INDESIT company

R24(EU)

F040190

Technical Documentation guidelines

51420a0 Exploded views

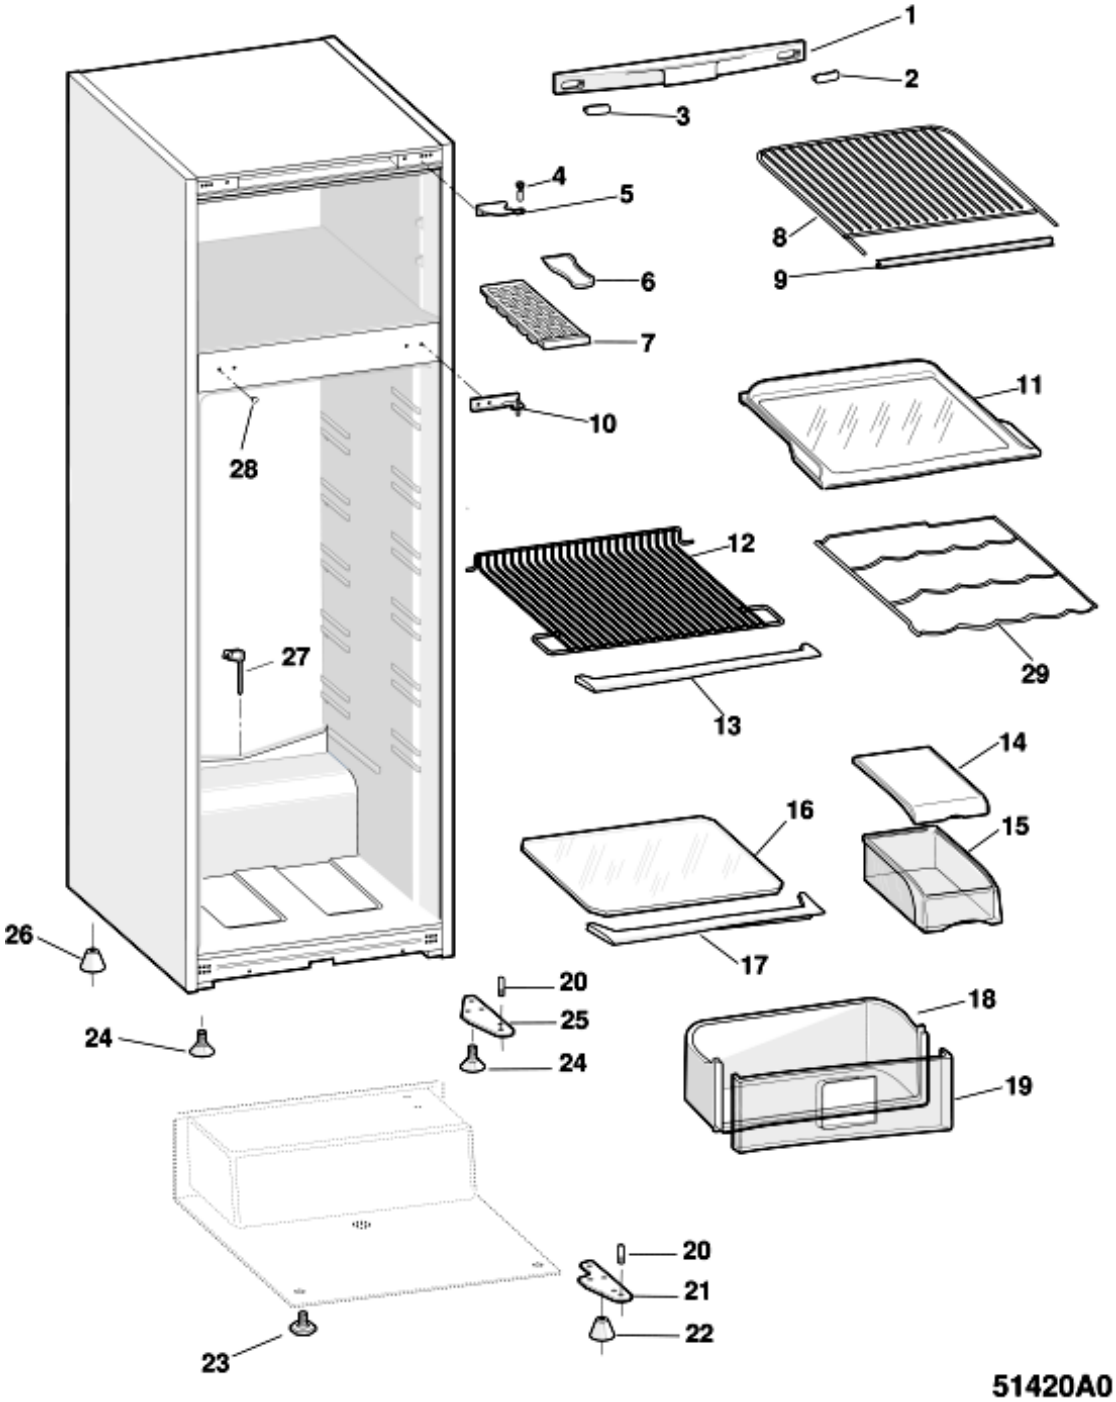
n3012c01: LOWER HINGE CHANGE

LOWER HINGE CHANGE

51421h0 Exploded views

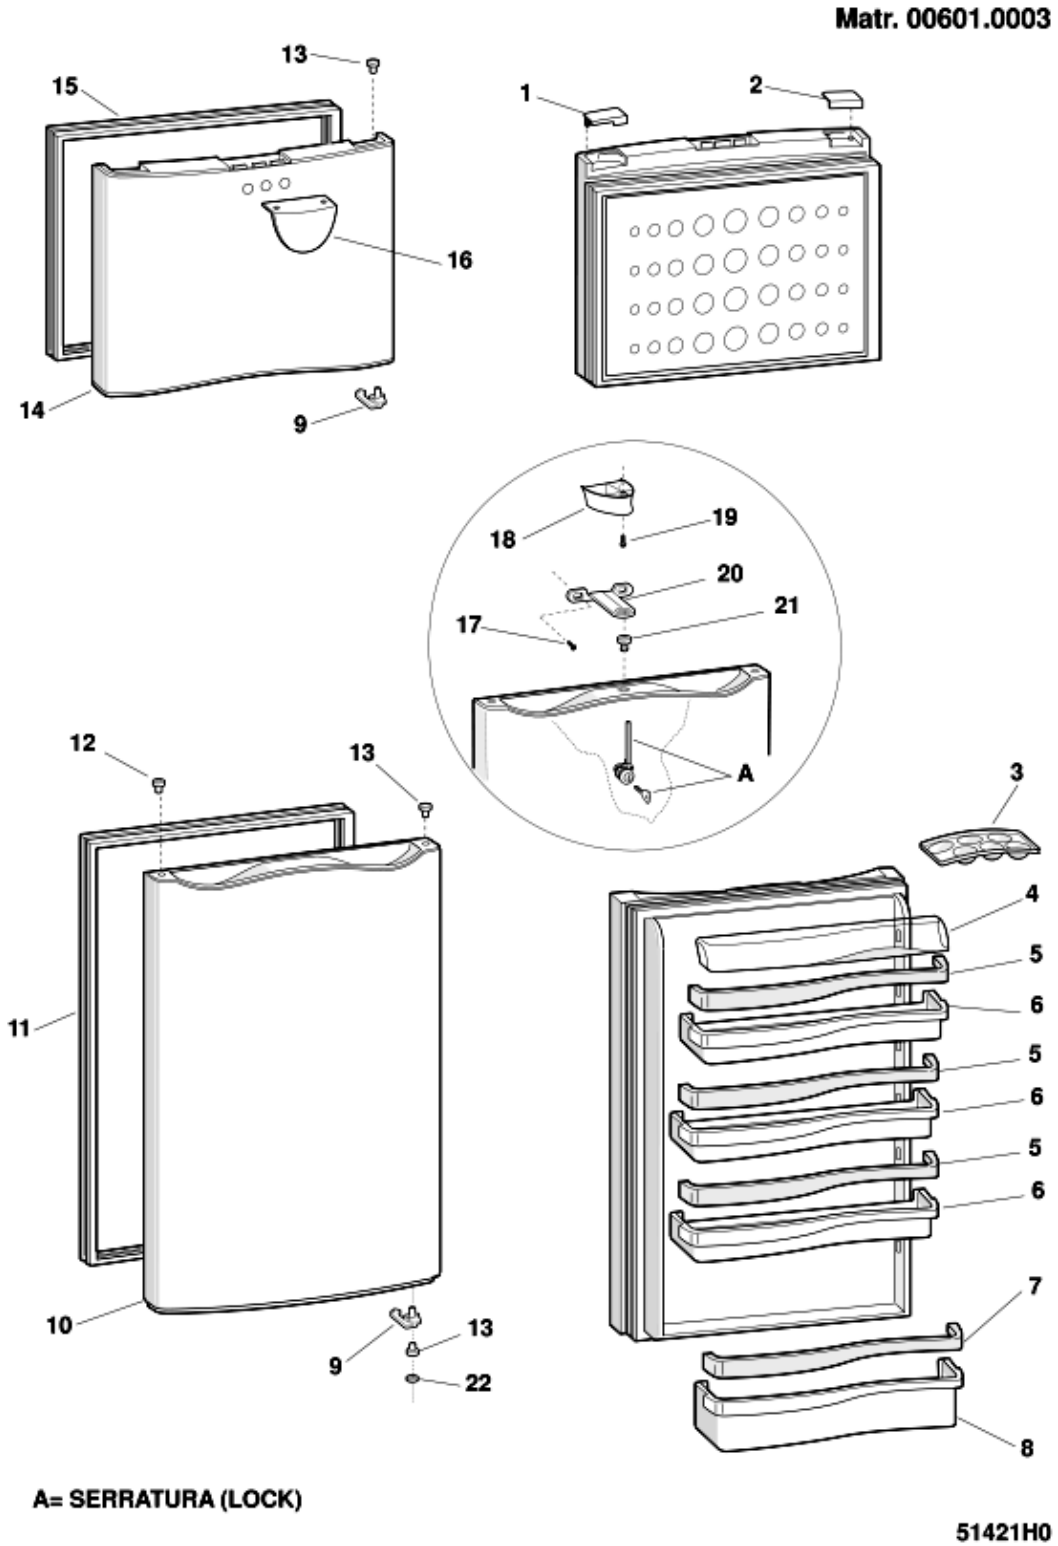
n1025110: Little lids for the door panel for the right opening version Indesit 2000 - 600 mm wide

From October 2001, little lids for door panel are available for the SAT code, to use on refrigerators and on combined-freezers (600mm wide), belonging to the series Indesit 2000, when the door opening is changed from right to left.
In fact, only on the product, which has the right hinges, the little lids of the piece of furniture are reversible; whereas those belonging to the door panel are specific for the right door opening.
The little lids for the version with left hinges are contained in specific coloured kit, which contain also the taps for closing the holes on a piece of furniture, which remain free on the opposite site of the central hinge.
It is important to remember that the holes to fix the central hinge are not present on the left site of the piece of furniture, when the door opening is converted. The holes are indicated only with a punching. The holes have been done after the work-ending with a 3mm bit

Kit of little lids for the door-panel of left version

084358 - WHITE KIT OF LEFT UPPER DOOR-COVERING
084361 - SILVER KIT VER-647 OF UPPPER LEFT DOOR-COVERING
084362 - BLUE KIT OF UPPER LEFT DOOR-COVERING
084363 - YELLOW KIT OF UPPER LEFT DOOR-COVERING
084364 - BEAVER-COLOURED KIT OF UPPER LEFT DOOR COVERING
084360 - ALUMINIUM-COLOURED KIT OF UPPER LEFT DOOR-COVERING

n3011e00: CHANGED EGG HOLDER FROM PW TO TRANSPARENT

CHANGED EGG HOLDER FROM PW TO TRANSPARENT

5142220 Exploded views

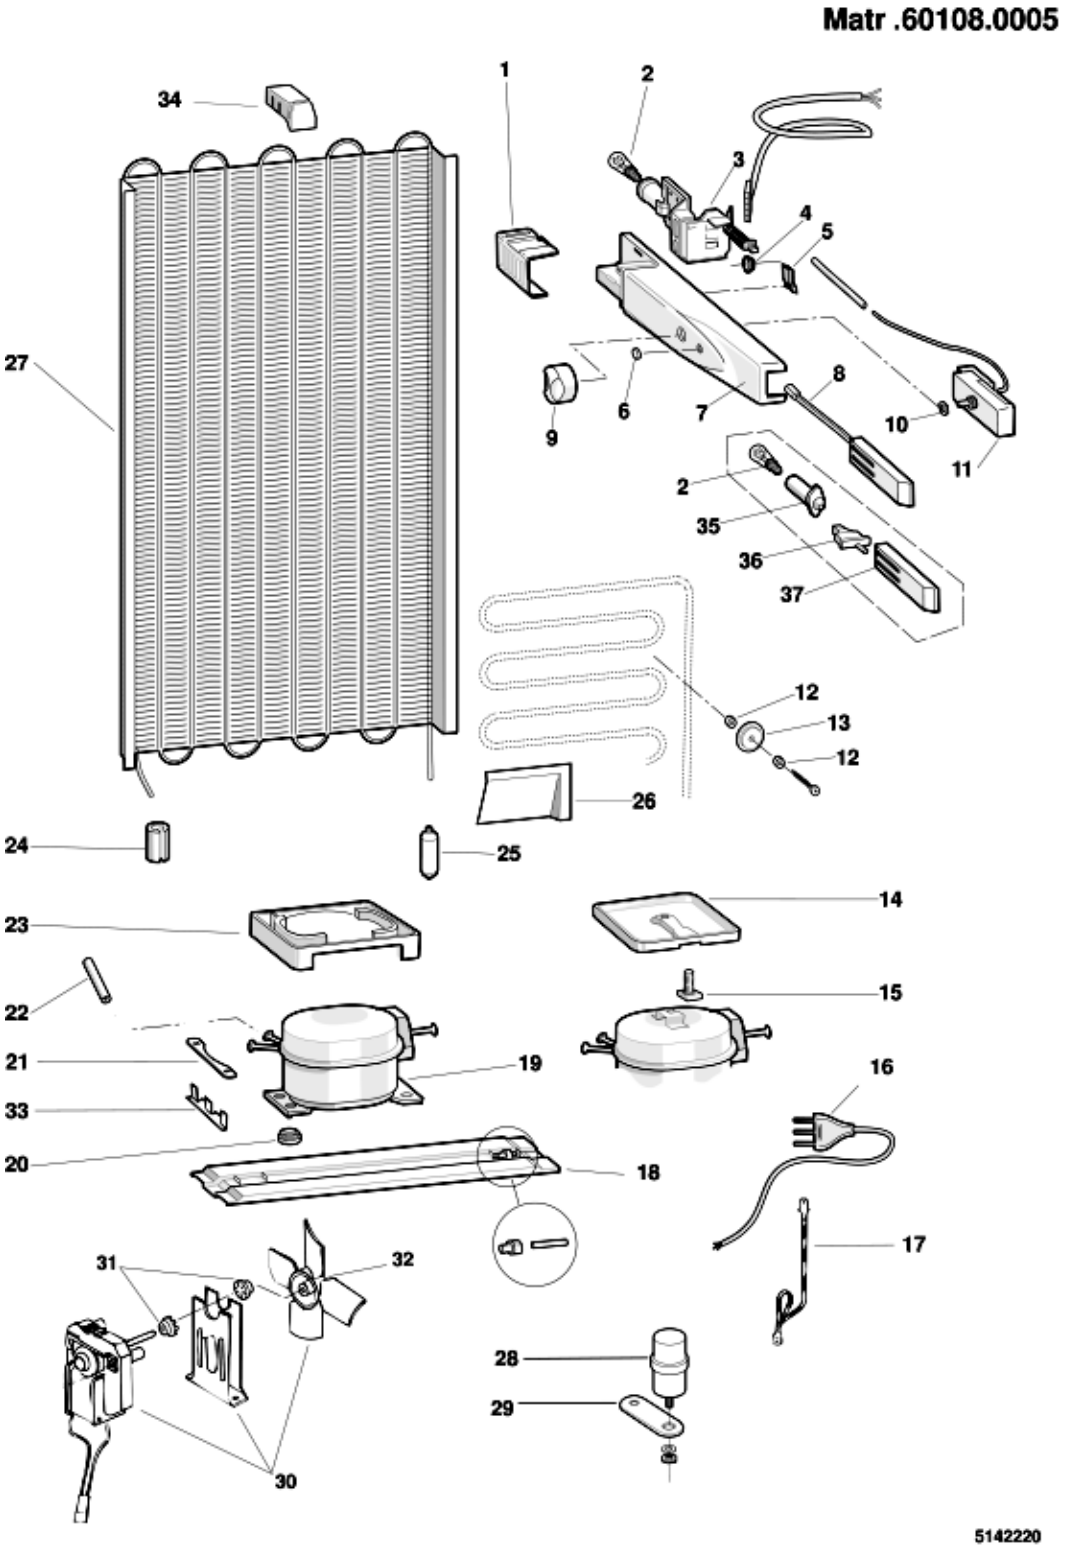
n1025065: Giugiaro-Vossloh thermostat box kit (low Ambient Temp. +16?C)

As of February-2001 (serial no. 10201.0001), the "thermostat box KIT for low ambient temperatures" is being handled with part number 076283 and is to be used on Indesit brand double-door refrigerators that have the Giugiaro thermostat box fitted on them (048503 - 066297).
The kit should be used exclusively to solve those problems obtained due to the poor performance of the freezer due to an ambient temperature below +16°C.
The kit is innovative, as it has a 6.6 Watt resistance fitted inside the thermostat box that should be activated by the toggle switch with a rubber protection situated underneath the thermostat knob. The switch is activated when the ambient temperature drops below +13°C (contacts closed. See the wiring diagram included in the kit).
This resistance heats up and enables the thermostat to be reactivated, thereby allowing the appliance to operate correctly.
On the thermostat box, the resistance is glued onto an aluminium plate (152x42) itself glued to the box.

When replacing the thermostat box, no components should be re-used, and this includes the wiring.
The wiring in the kit has terminals with fastons for connecting them to the compressor's terminal board; in the event of different solutions, then make the suitable adjustments as necessary.
Moreover, the thermostat box in the kit was obtained from the Giugiaro one (066229) with the Vossloh lamp holder and the Eltek switch. On this box, the position of the fixing hole was moved 15 mm up; therefore, on the models that are fitted with the Giugiaro thermostat box (048503), the hole on the cabinet should be remade before mounting the kit.
Moreover, on the models that use the hidden bulb thermostats, the position of the mark should be remade on the thermostat in the kit and, if necessary, the sheath protecting the bulb should be removed.

This is a list of the parts that make up the kit that are handled as spare parts:

066295 - LAMP HOLDER (VOSSLOH) 250V E14
066296 - GIUGIARO-VOSSLOH WHITE SWITCH ROD (L.110)
066294 - LIGHT SWITCH 250V NC (ELTEK)
048507 - WHITE-BLUE GIUGIARO THERMOSTAT KNOB
039131 - A13-0184/091X6483 CENTER POST THERMOSTAT
009888 - CABLE CLAMP
006522 - 220-240V/15W LAMP (E14)
048505 - LAMP COVER (GIUGIARO)
076442 - 6.5/7.7 W 220/240V RESISTANCE (FASTON)
032399 - TOGGLE SWITCH PROTECTION (21X15)
032395 - TOGGLE SWITCH 250V S.A1 (21X15)
